**HORIZONTAL DIRECTIONAL DRILL ANALYSIS
WALTONVILLE ROAD CROSSING
PADEP SECTION 105 PERMIT NO.: E22-617
PA-DA-0056.0000-RD
(SPLP HDD No. S3-0080-16)**

The 16-inch pipeline HDD is referred to herein as HDD S3-0080-16.

ORIGINAL HORIZONTAL DIRECTIONAL DRILL DESIGN SUMMARY: 16-INCH

HORIZONTAL DIRECTIONAL DRILL REDESIGN

NOTES			REF. DRAWING			REVISIONS						 <div>Sunoco Logistics Partners L.P.</div>  <div>TETRA TECH ROONEY (303) 792-5911</div>		<div>SUNOCO PIPELINE, L.P.</div> <div>HORIZONTAL DIRECTIONAL DRILL WALTONVILLE ROAD PENNSYLVANIA PIPELINE PROJECT</div>		SCALE: 1"=200'		DWG. NO: PA-DA-0056.0000-RDa-16

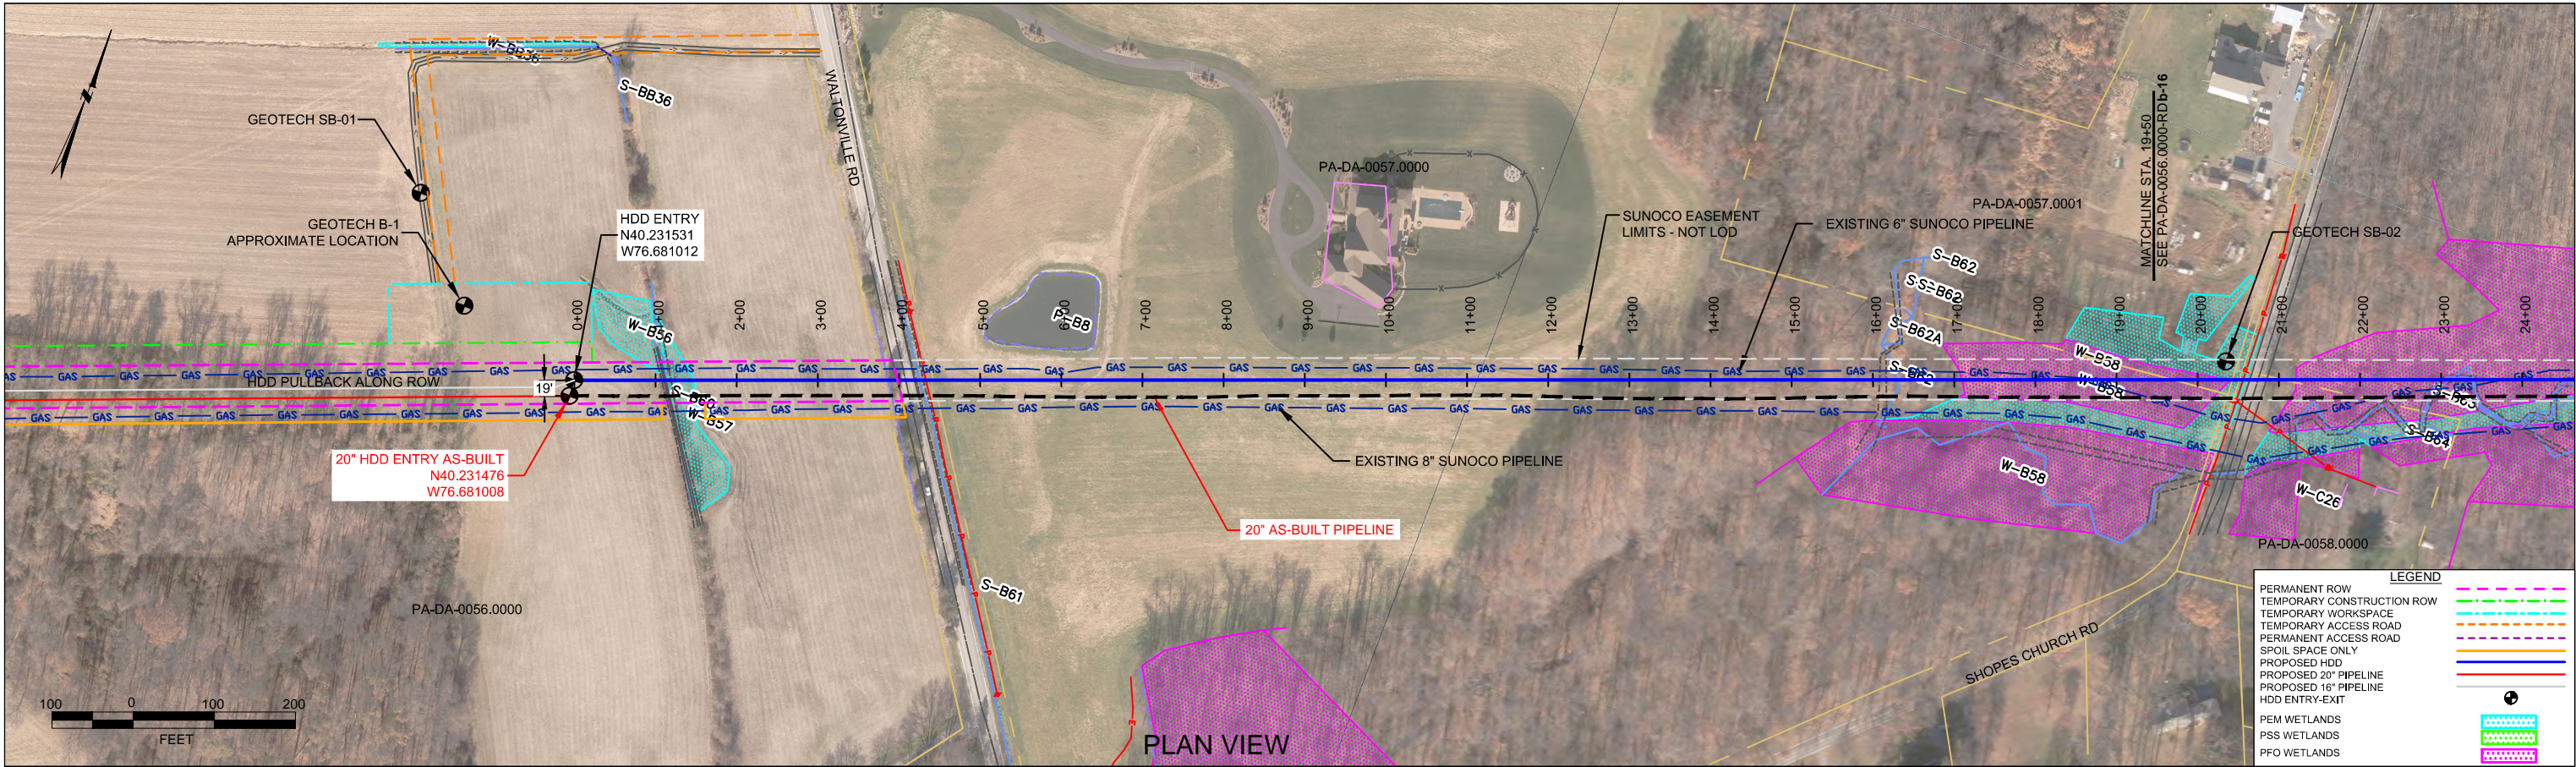
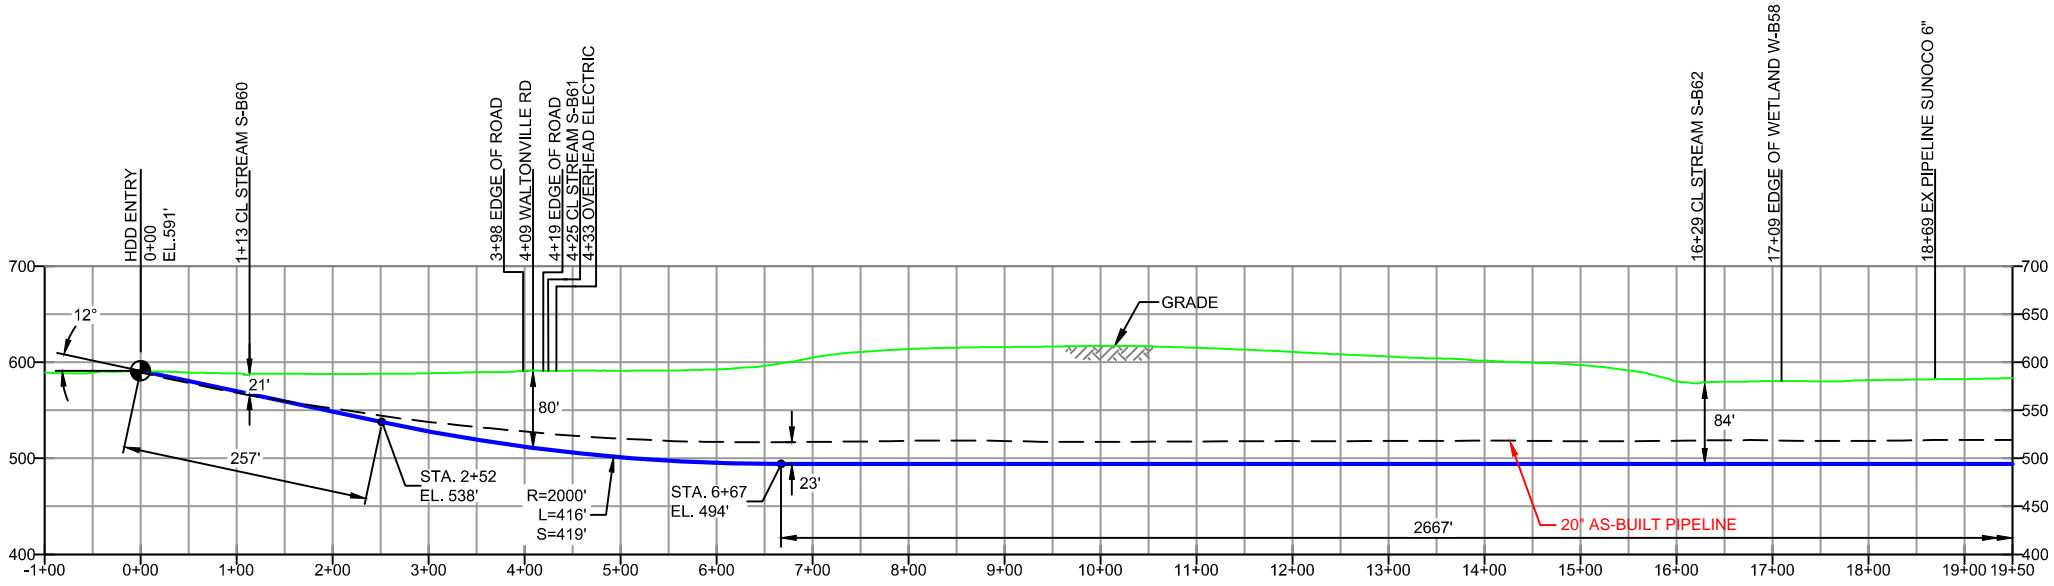
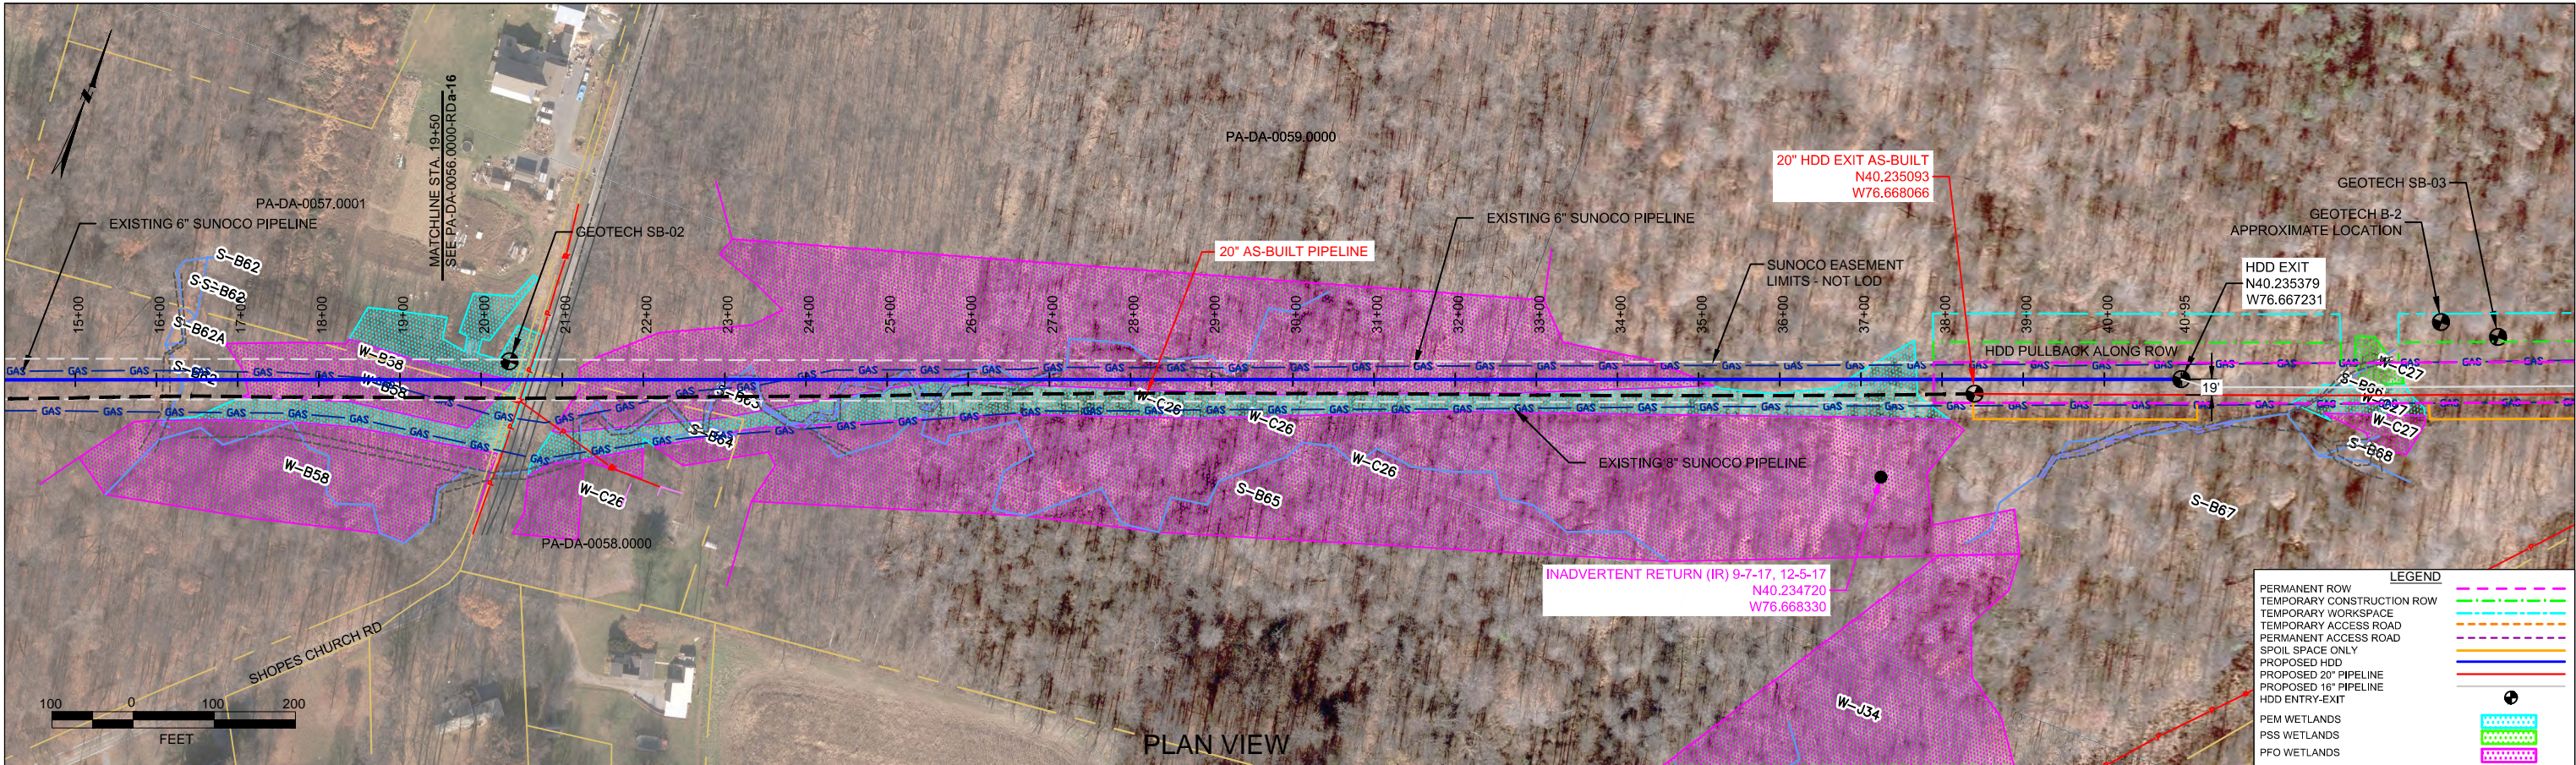
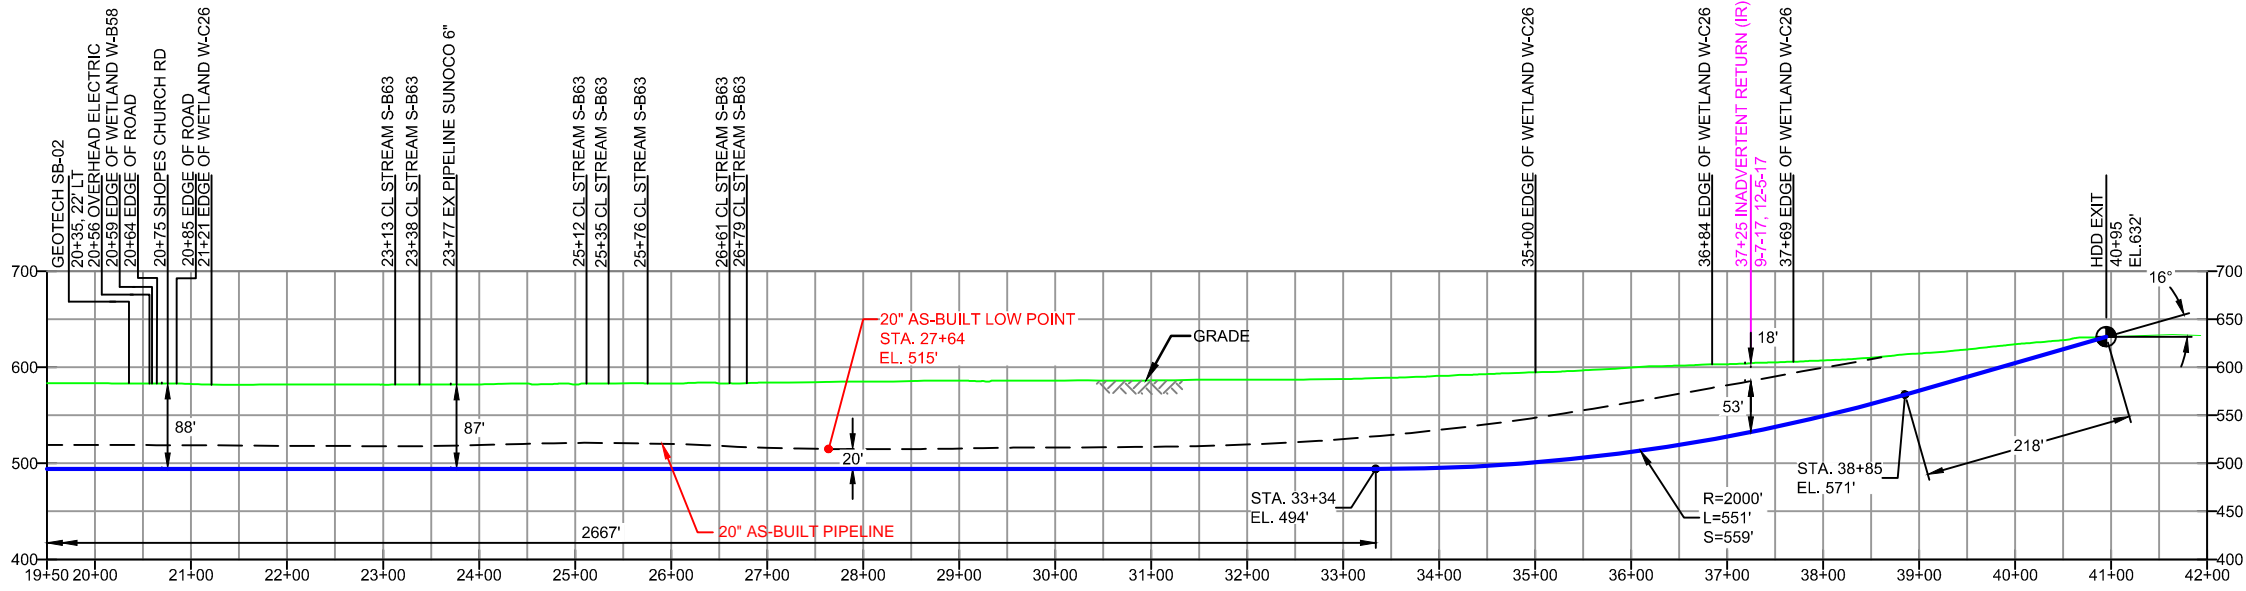
1. ALL COORDINATES SHOWN ARE IN LATITUDE AND LONGITUDE. ALL MSL ELEVATIONS ARE NAD83 2. STATIONING IS BASED ON HORIZONTAL DISTANCES.			ES-4.23	TO	ES-4.25	EROSION & SEDIMENT PLAN	EP4	DESIGN CHANGE - INCREASED DRILL EXIT ANGLE	MRS	02/13/19	RMB									02/13/19	AMC	02/13/19

NO.	DESCRIPTION	BY	DATE	CHK	DATE	APP	DATE
EP4	DESIGN CHANGE - INCREASED DRILL EXIT ANGLE	MRS	02/13/19	RMB	02/13/19	AMC	02/13/19
EP3	DESIGN CHANGE - EXTENDED DRILL AND UPDATED GEOTECH INFORMATION	MRS	12/07/18	RMB	12/07/18	AMC	12/07/18
EP2	REVISED PER PADEP COMMENTS RECEIVED 09-06-16	MRS	10/07/16	RMB	10/07/16	AAW	10/07/16
EP1	REVISED PER PADEP COMMENTS	DLM	05/17/16	RMB	05/17/16	AAW	05/17/16
EP		JTW	03/15/16	RMB	03/15/16	AAW	03/15/16
B	ISSUED FOR BID	MRS	09/22/15	RMB	09/22/15	AAW	09/22/15
